Belfield / Blackrock to City Centre Core Bus Corridor Scheme

NTA Observations on the Proposed Scheme Submissions and CPO Objections

September 2022

Figure 2.1: Extract 1 from General Arrangement Drawing

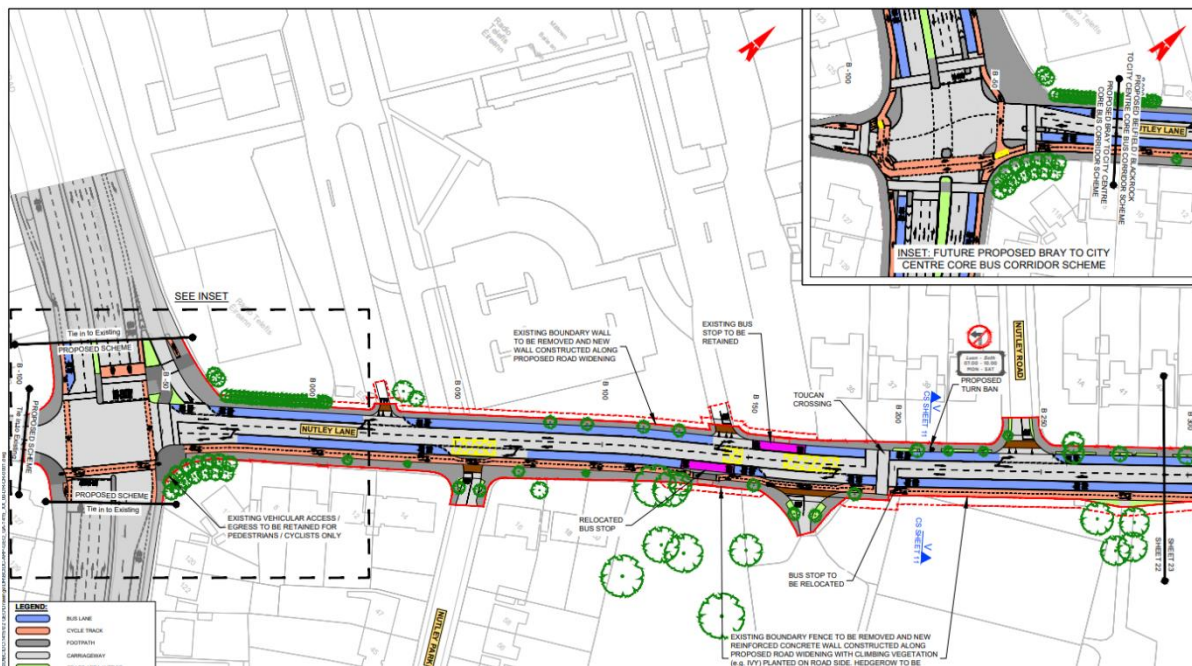
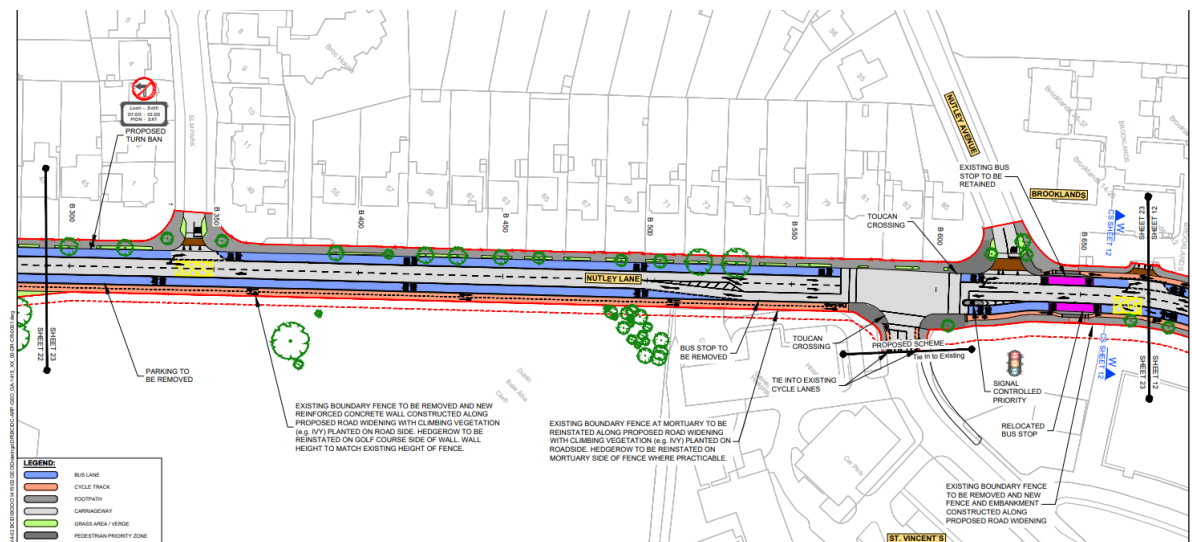
Extracts from drawing set **2. General Arrangement**, which are provided as an appendix to Chapter 4 in Volume 3 of the EIAR, are included below in Figure 2.1 and Figure 2.2.

Figure 2.48: extract from Figure 30 of Appendix A4.1 (Preliminary Design Guidance Booklet)

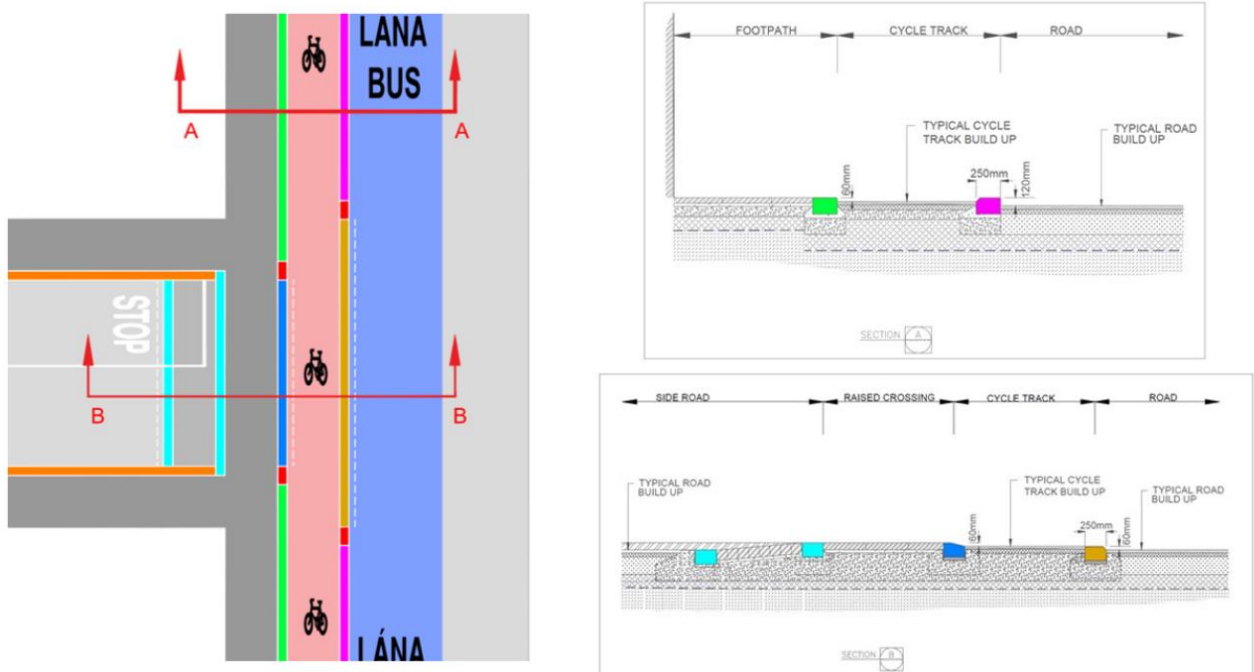
To ensure pedestrian priority at side roads, physical interventions in the form of raised table side entry treatments, and raised cycling infrastructure are proposed in line with Appendix A4.1 BusConnects Preliminary Design Guidance Booklet (PDGB) of the EIAR. Figure 30 of the PDGB (see Figure 2.48 below) illustrates how a footpath and raised-adjacent cycle track will cross an uncontrolled T-junction.

Figure 2.49: extract from Figure 30 of Appendix A4.1 (Preliminary Design Guidance Booklet)

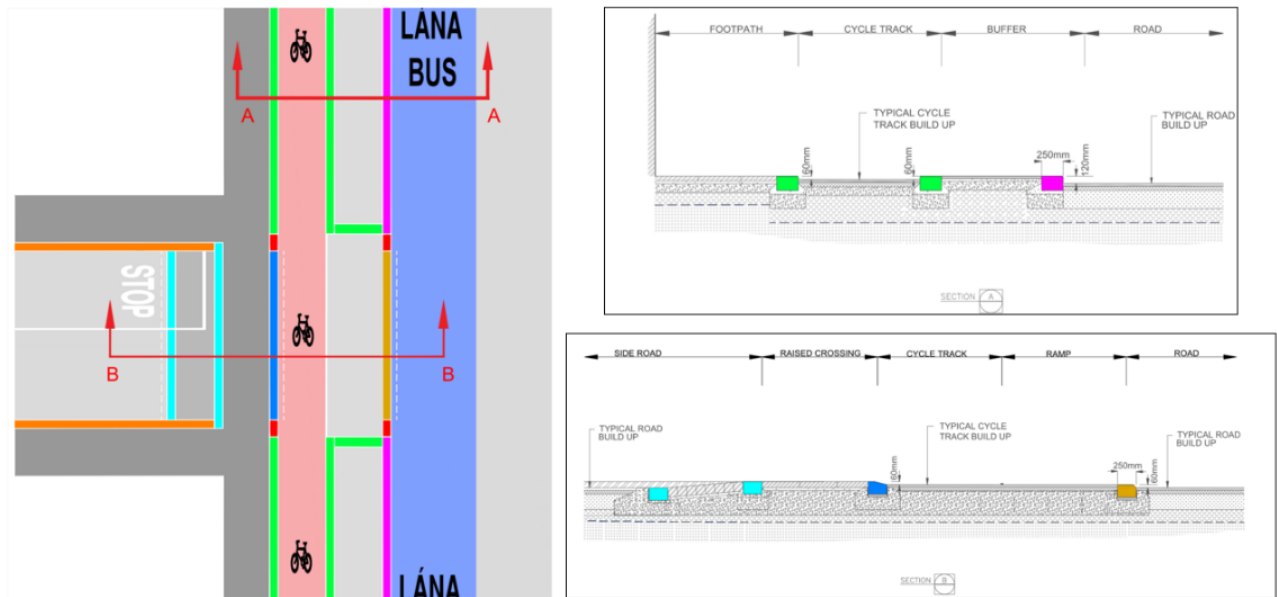
In situations where parking is provided on either side of a side road (Grotto Avenue, Raglan Road), Figure 31 of the PDGB (see Figure 2.49 below) details how the platform upon which the raised-adjacent cycle track will cross an uncontrolled T-junction, extends to meet the kerb at the edge of the carriageway. Localised road markings will define the roadside edge of the cycle track across the side road.

Figure 2.50: Facilities for Inbound Cyclists from Monkstown Road

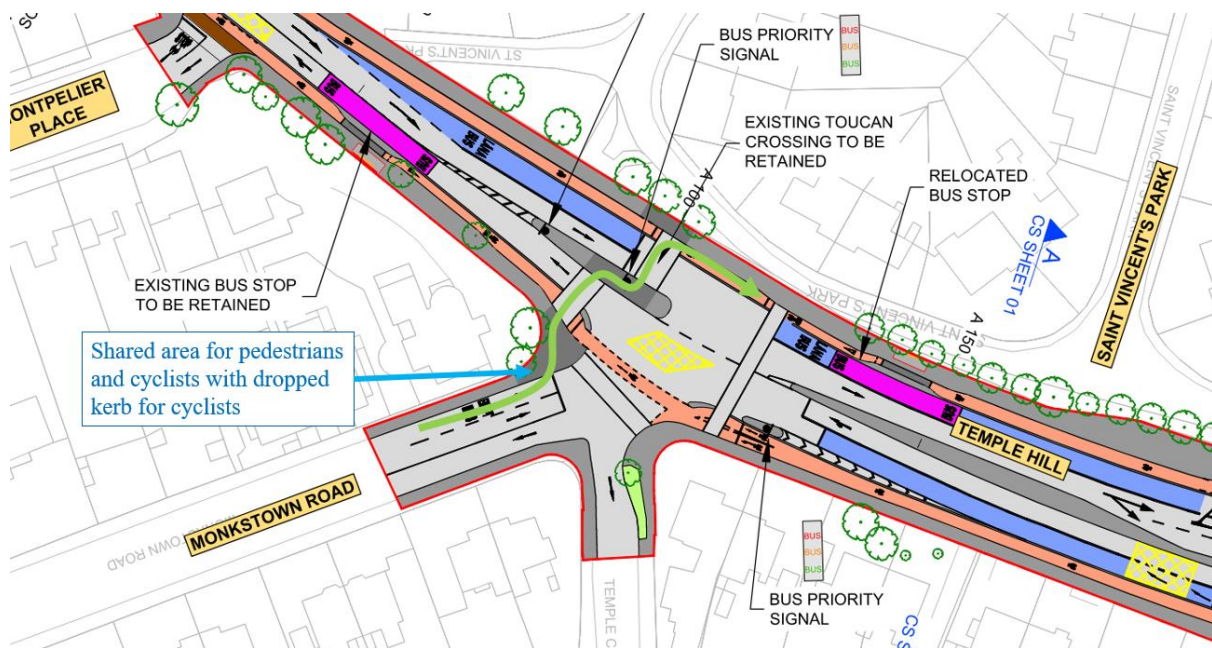
A design amendment has been suggested at the Monkstown Road approach to the Temple Hill junction to facilitate cyclists travelling inbound from Monkstown Road to Temple Hill (northbound). Cycle movement is accommodated via the proposed shared area at the corner of the junction to allow the inbound cyclist on Monkstown Road use the existing Toucan crossings (which will be retained) on the southern arm of the junction. This enables the inbound cyclists from Monkstown Road gain access to the inbound cycle track on Temple Hill as illustrated in Figure 2.50 below and outlined in section 4 (Junction Design and Modelling Results) of Appendix A6.3 Junction Design Report for the Temple Hill / Temple Crescent junction.

A fully protected junction was considered at this junction, however, the tall, large CCTV camera pole in the central median of the southern arm of the junction is a constraint to this layout, including a direct crossing to replace the existing staggered crossing, therefore, the Proposed Scheme will tie in to all existing facilities on all arms at the southern extents of the Proposed Scheme.

Figure 2.51: New Soft Landscaping Areas at Sion Hill / Castledawson

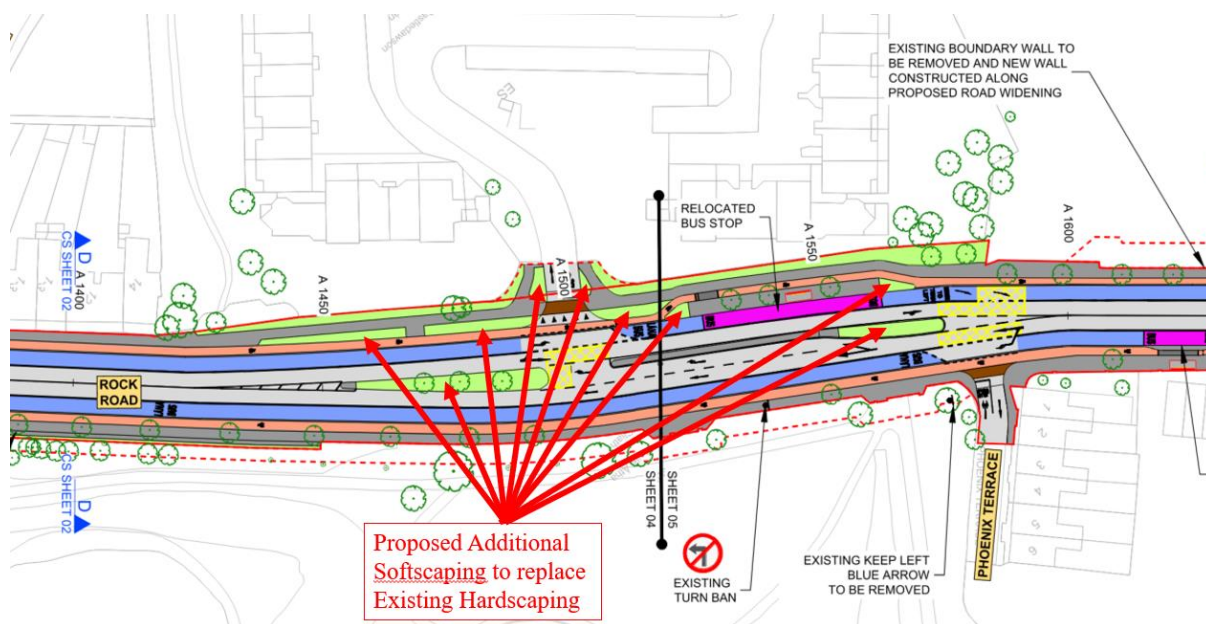
The existing central medians at the entrance to Sion Hill / Castledawson provide an opportunity to create soft landscaping areas in a boulevard-style at this location and have been retained for this purpose. The length of the right turn pocket is defined by the existing median which is being retained for landscaping purposes. **Figure 2.51** below illustrates the amount of additional soft landscaping that is proposed as part of the landscaping design for the Proposed Scheme.

Figure 2.52: Extract from Figure 12.6 showing location of Three-Cornered Garlic

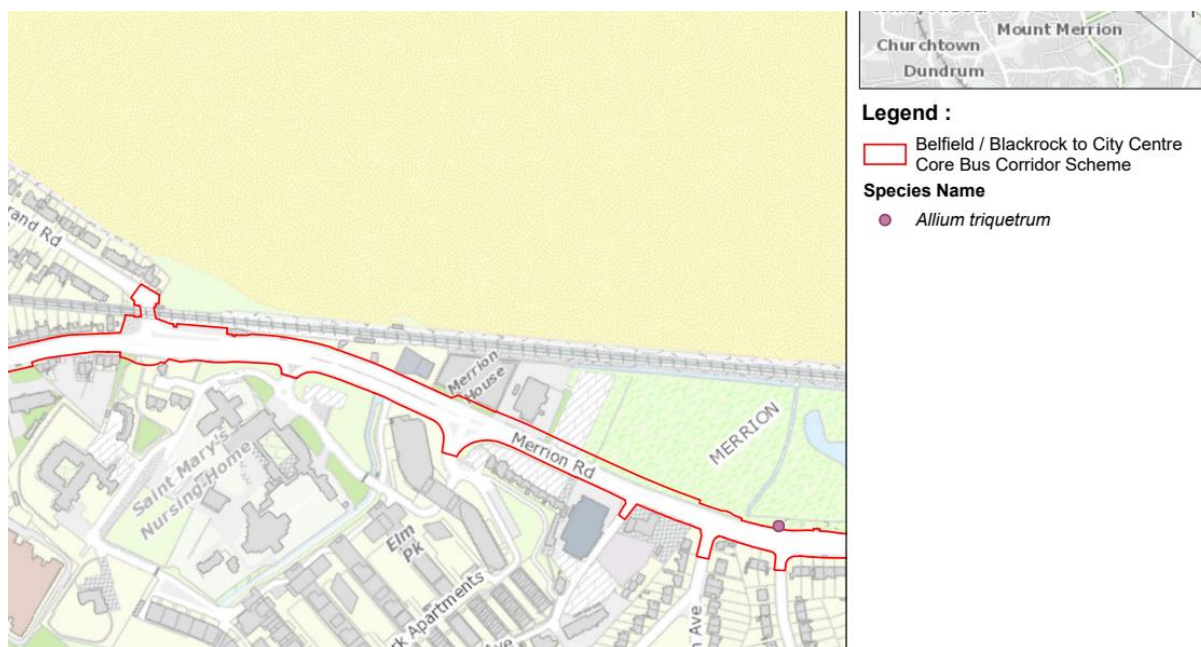
The presence of Three-cornered garlic (*Allium triquetrum*) has been identified near the viewing area located adjacent to the north-western corner of Booterstown Marsh. The location of this non-native invasive species is shown in Figure 2.52, which is an extract of Volume 2 – Figures: Part 2 of 2. The Proposed Scheme in this location does not consist of road widening, and all works will be contained within the existing boundary, separated from the Booterstown Marsh area by an existing wall.

Figure 2.58: Proposed Junction Layout as part of the Proposed Scheme

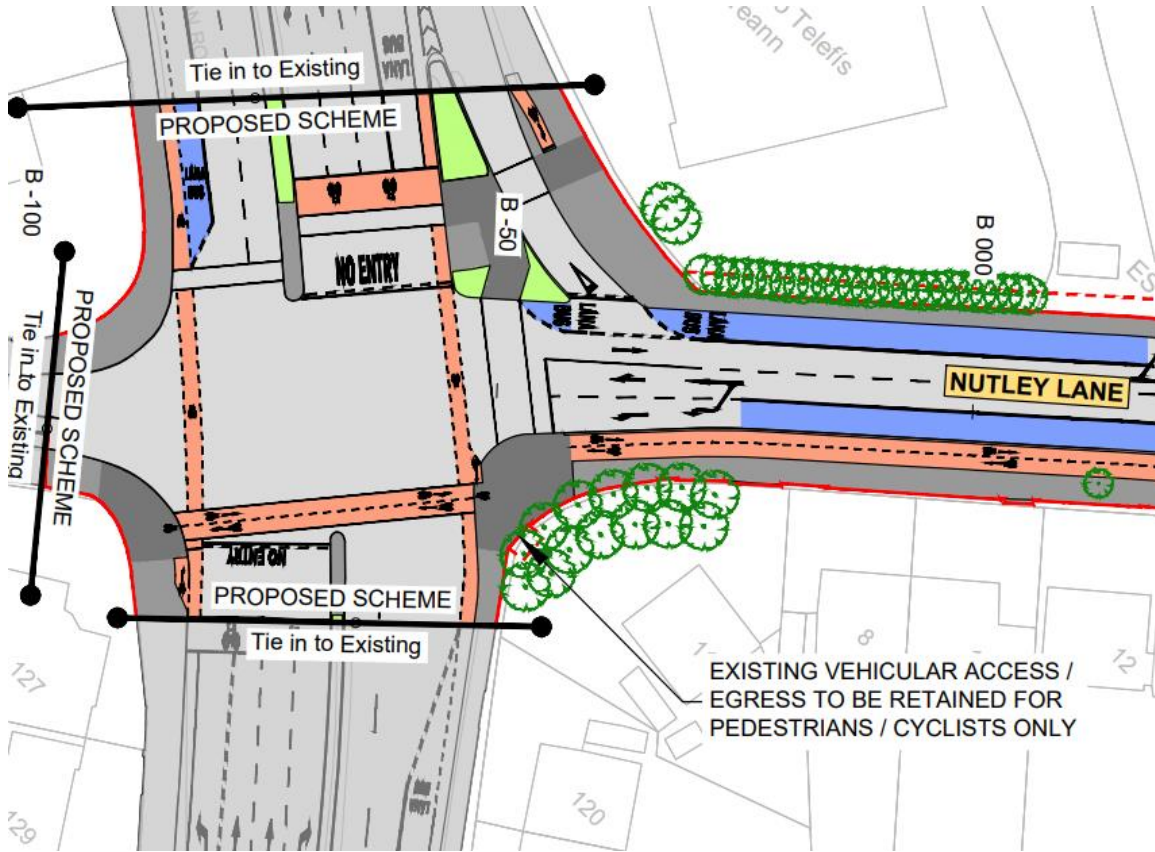
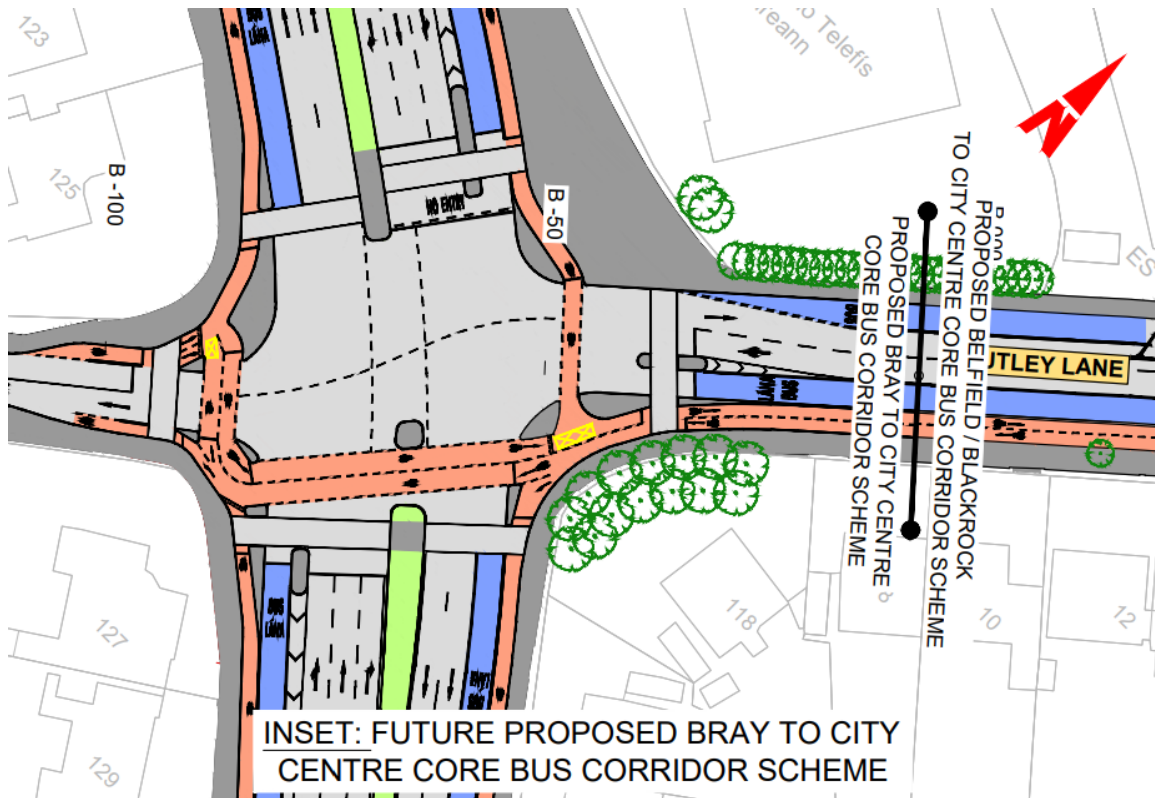
As summarised in the Junction Design Report, at the Nutley Lane / Stillorgan Road Junction a pedestrian crossing is not proposed on the southern or western arms (consistent with the existing scenario). A staggered pedestrian crossing is proposed on the northern arm (consistent with the existing scenario). It is noted that the existing pedestrian crossing provision is proposed to be retained at this junction in the interim prior to the delivery of the Bray to City Centre Core bus Corridor Scheme, subject to the approval of that scheme, which proposes more significant junction alterations. A straight crossing at this location would result in a crossing distance of greater than 19m (see Section 5.6 of the PDGB) and the overall junction performance and people movement would be reduced which is not desirable at this location due to the dual-carriageway nature of the R138 Stillorgan Road. As outlined in Section 3.3 of the Preliminary Design Report, only minor interventions are proposed under the Proposed Scheme at this junction, associated with a new two-way cycle crossing facility. This layout is shown in Figure 2.58 below. More comprehensive improvement measures are proposed at this junction as part of the Bray to City Centre CBC scheme, which includes for the provision of pedestrian crossings on all arms of this junction. This layout is shown in Figure 2.59 below.

Figure 3.4: Proposed new Layout at Blackrock Clinic

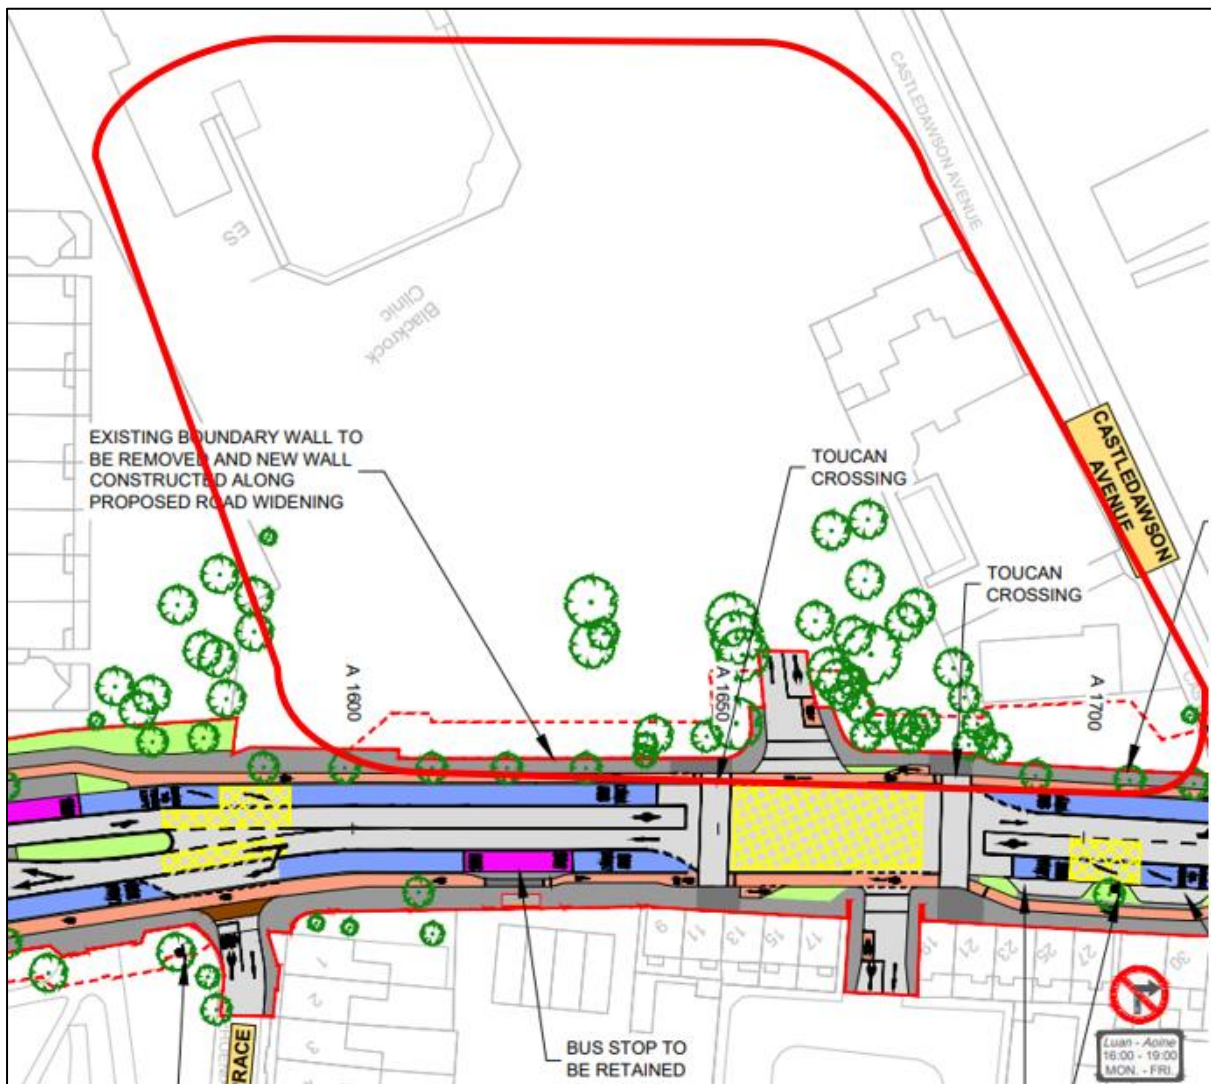
- The relevant extract of the General Arrangement Drawings in the EIAR, Volume 3, Chapter 4 Proposed Scheme Description Figures, as per Figure 3.4 below;
- the existing aerial views in Figure 3.5, and
- the existing street view in Figure 3.6.

Figure 3.9: Proposed new Layout at Meta, Merrion Road

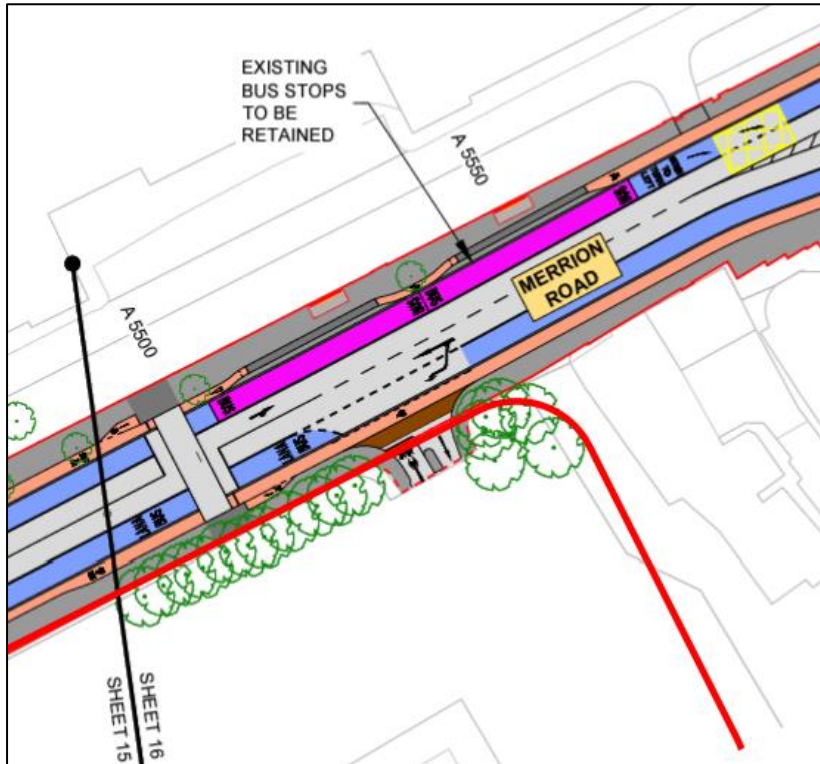
- The relevant extract of the EIAR Chapter 4 Proposed Scheme Description Appendix the General Arrangement drawings in Figure 3.9,
- The existing aerial views in Figure 3.10 and
- The existing street view in Figure 3.11 below.
